Annexure A

Pavillion Residences No 3 Pty Limited v Northern Beaches Council

Amended Plans and Documents

PROJECT TITLE: RESIDENTIAL DEVELOPMENT
21 WHISTLER ST MANLY

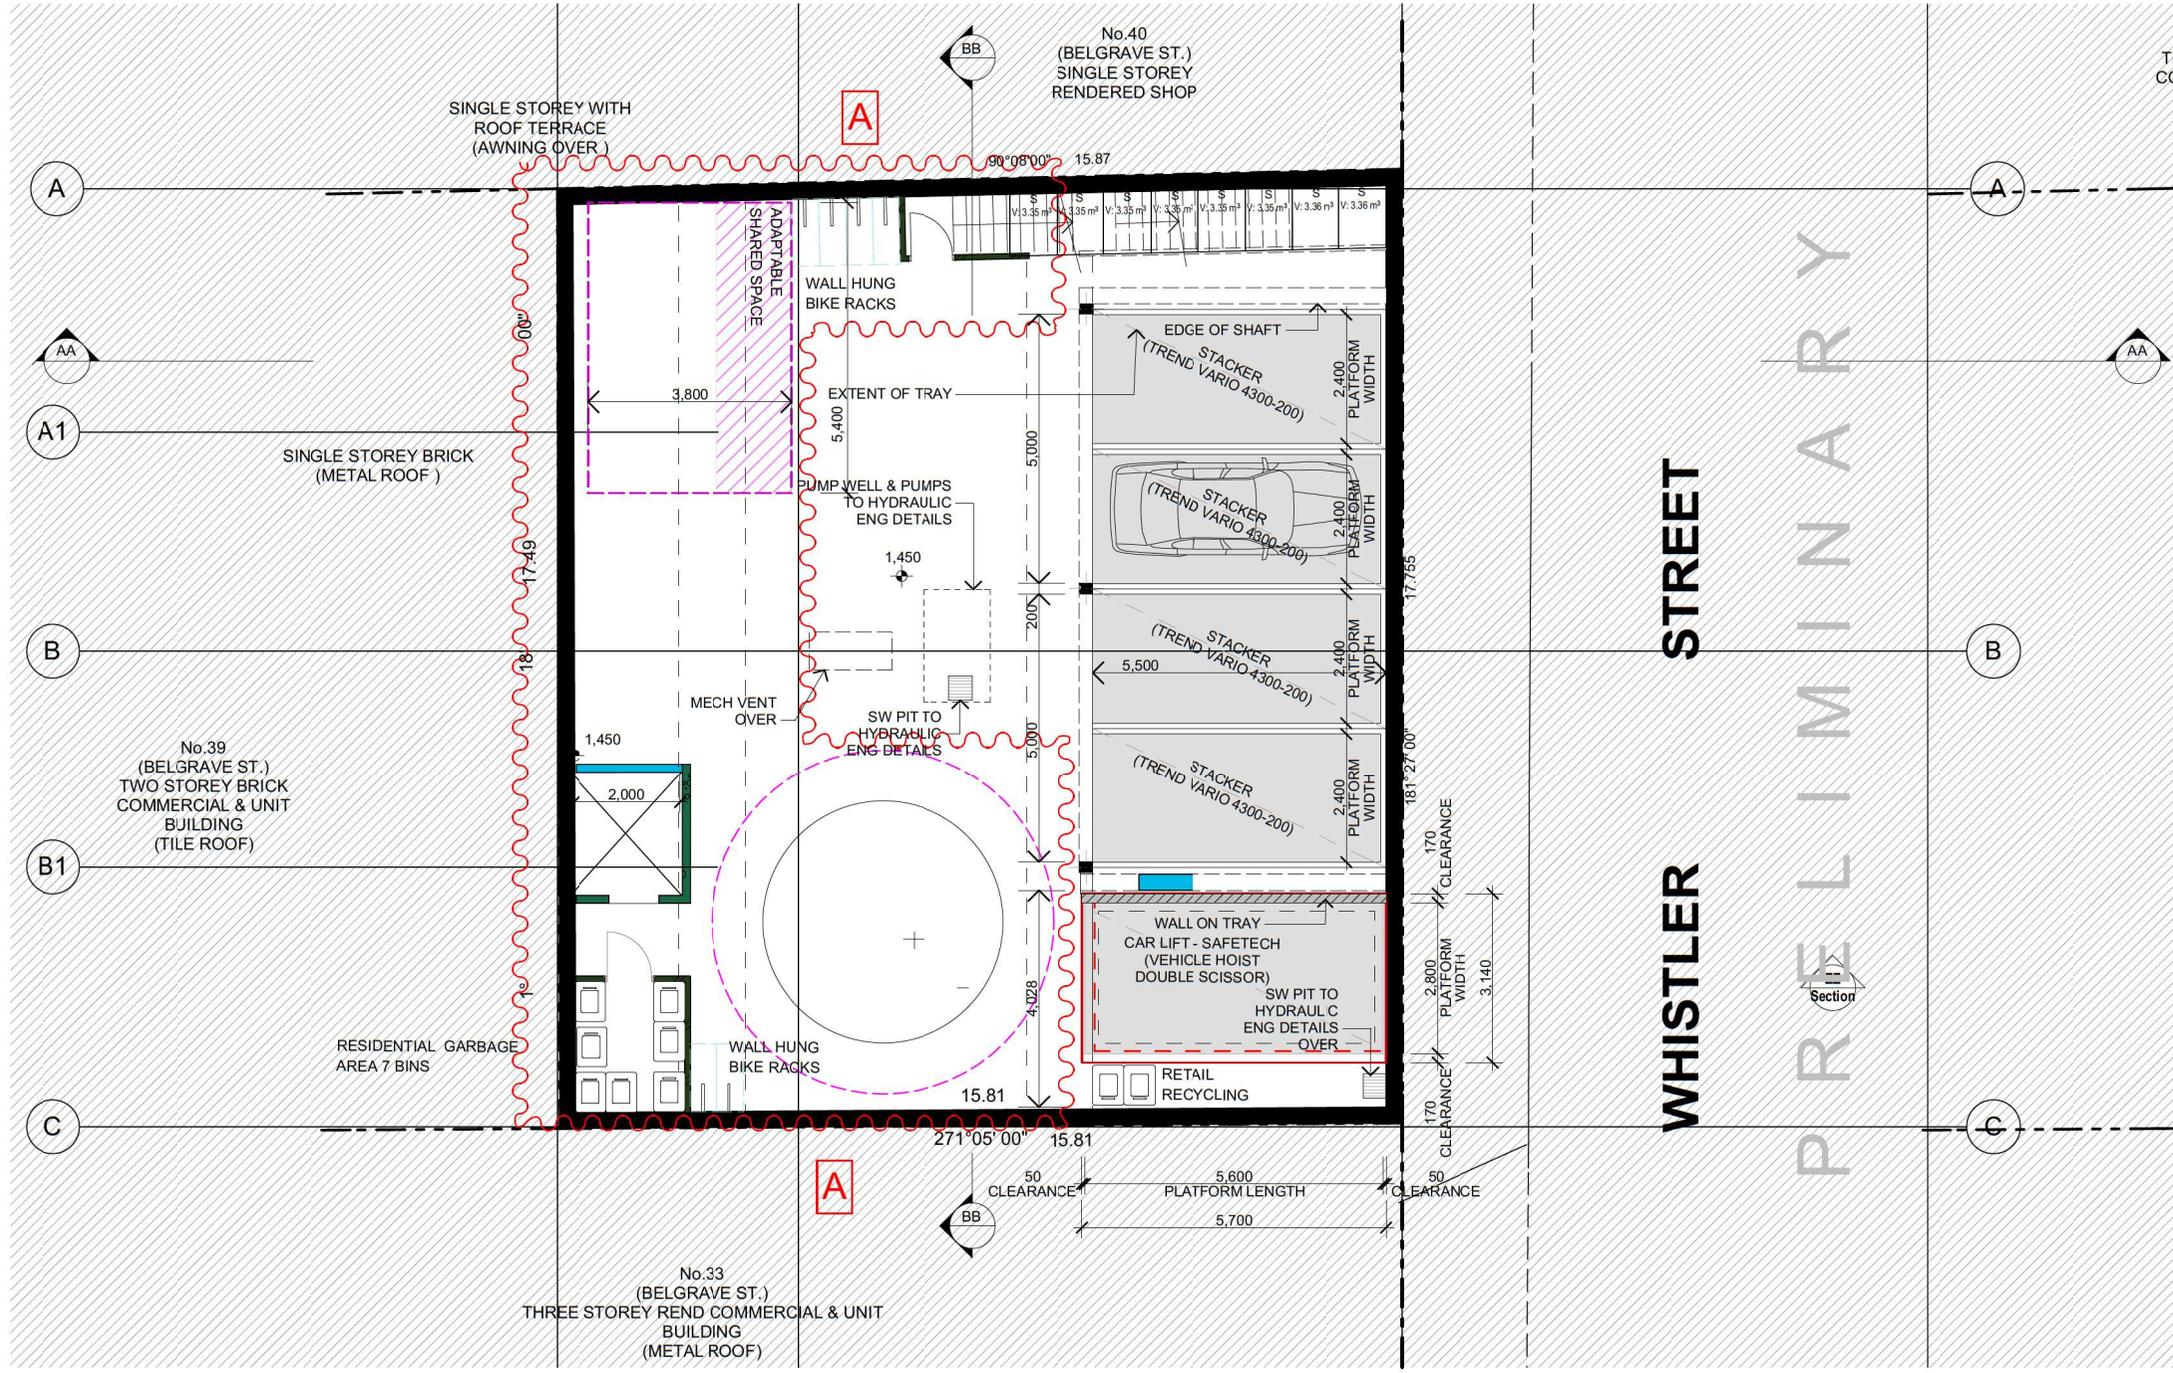
<table><tr> <th>DATE</th> <th>REV</th> <th>DESCRIPTION</th> </tr><tr> <td>05/05/20</td> <td>D</td> <td>LIFT + ADAPTIBLE CARPARK MIRRORRED</td> </tr></table>

DRAWING TITLE: DA02

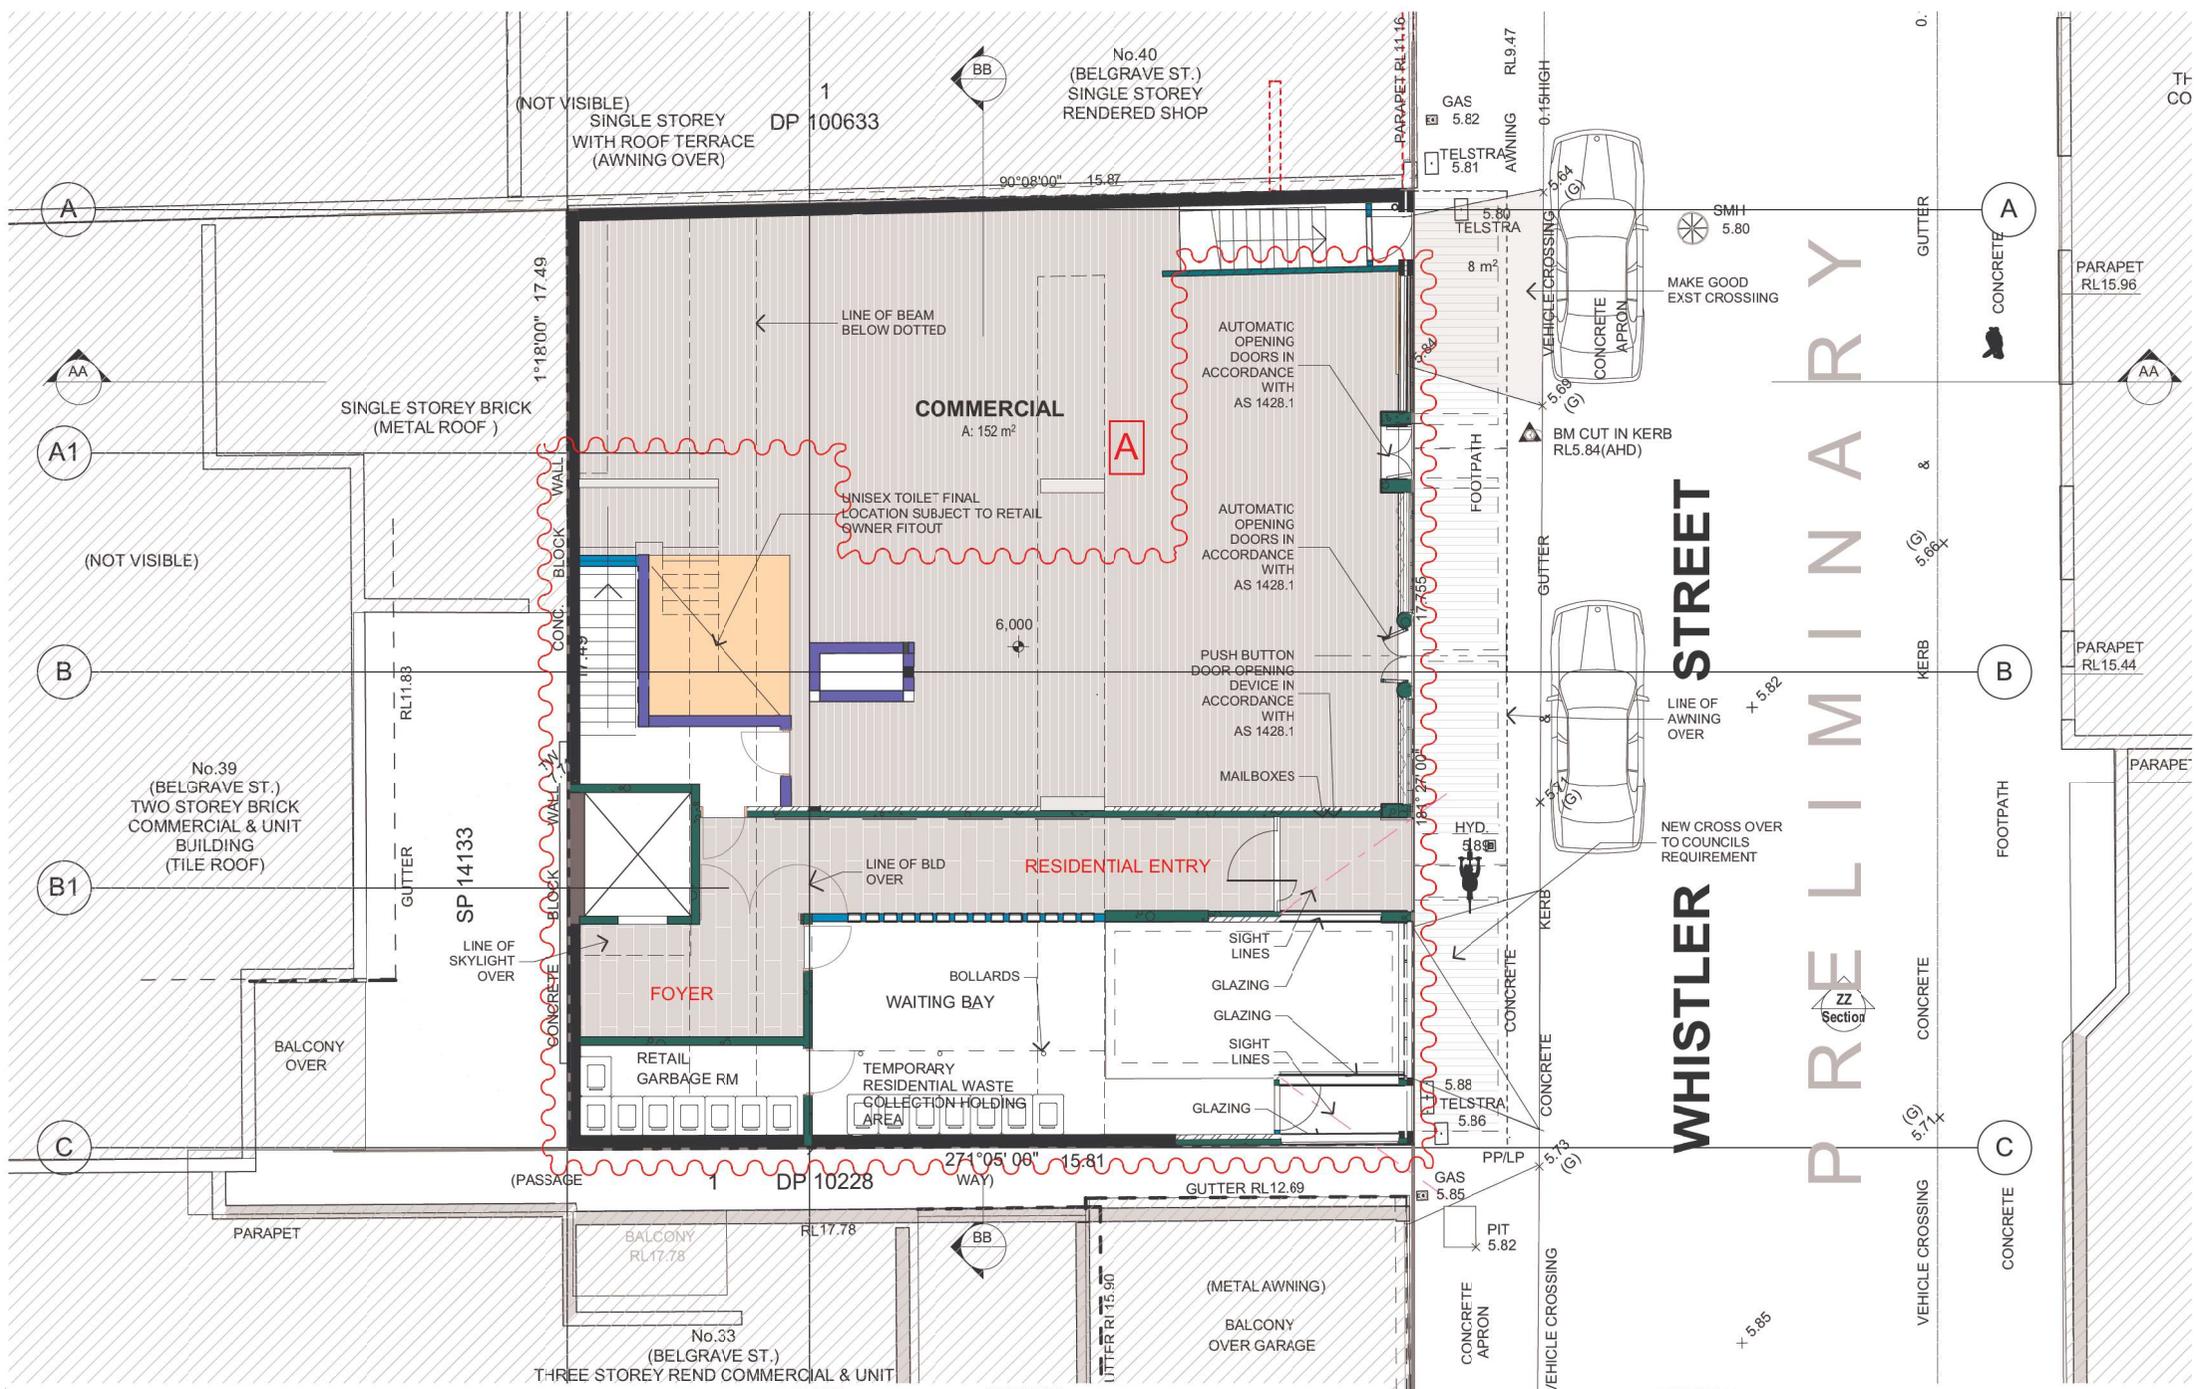
DATE	REV	DESCRIPTION
29.03.19	A	RECONFIGURE ENTRY & LIFT FOYER ADDED WAITING BAY NEW LOCATION OF BIN AREA RECONFIGURE RETAIL 01.02
04.06.19	B	CHANGE OF STONE AT BASE REORGANIZATION OF WAITING BAYS AT STREET RECONFIGURATION OF STREET FACADE
24.03.20	C	GARBAGE AREA MODIFIED
05.05.20	D	RESIDENTIAL ENTRY LIFT + STAIRS MODIFIED TO IMPROVE SIGHTLINES TO CARLIFT

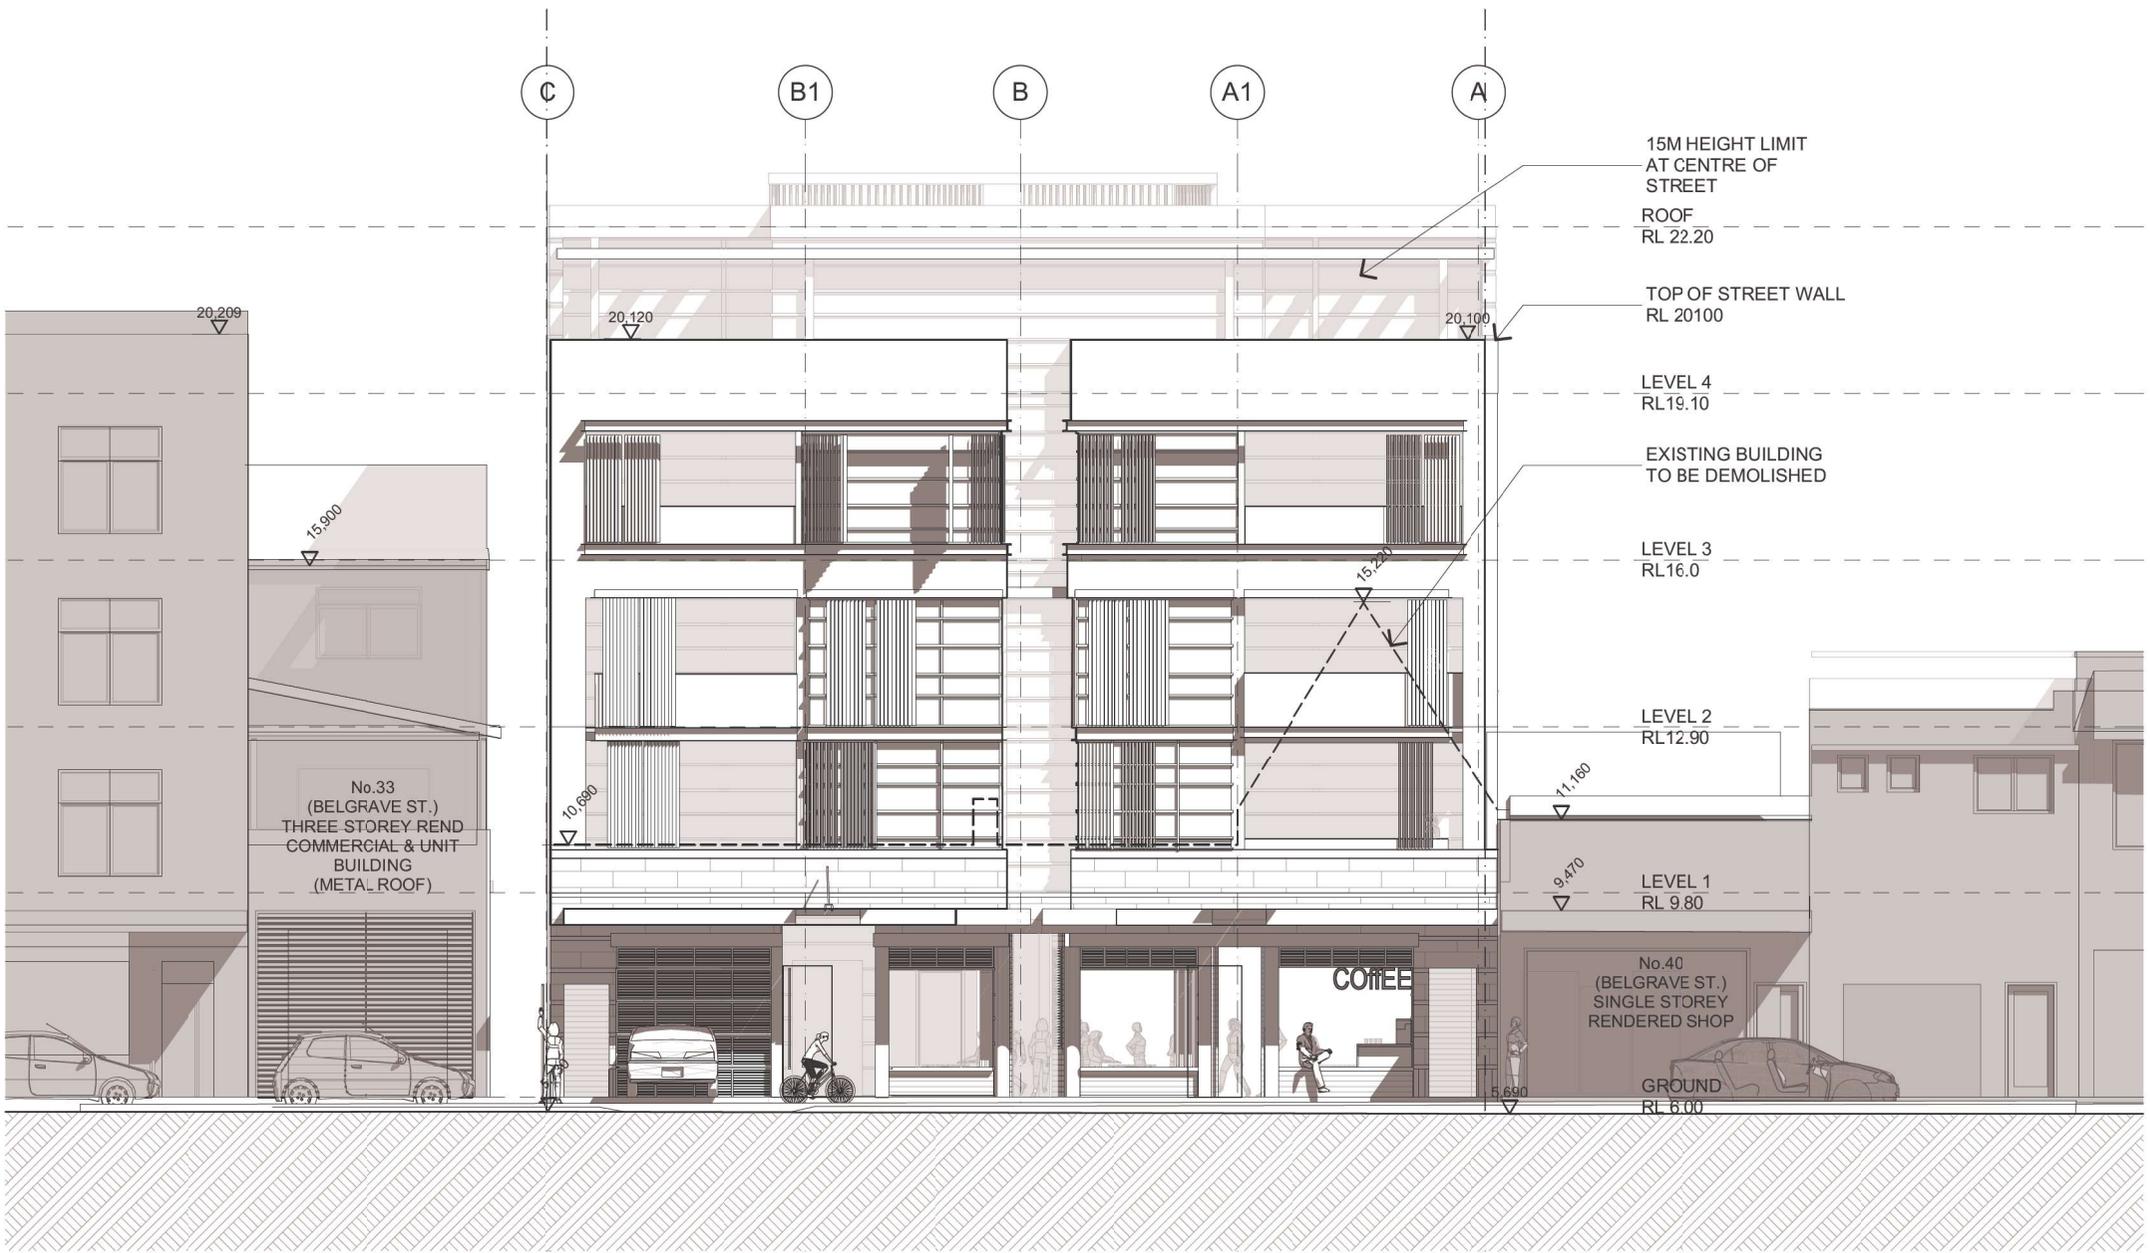
<table><tr> <th>DATE</th> <th>REV</th> <th>DESCRIPTION</th> </tr><tr> <td>05/05/20</td> <td>B</td> <td>GROUND FLOOR FACADE ALTERED TO IMPROVE VEHICULAR SIGHTLINES</td> </tr></table>
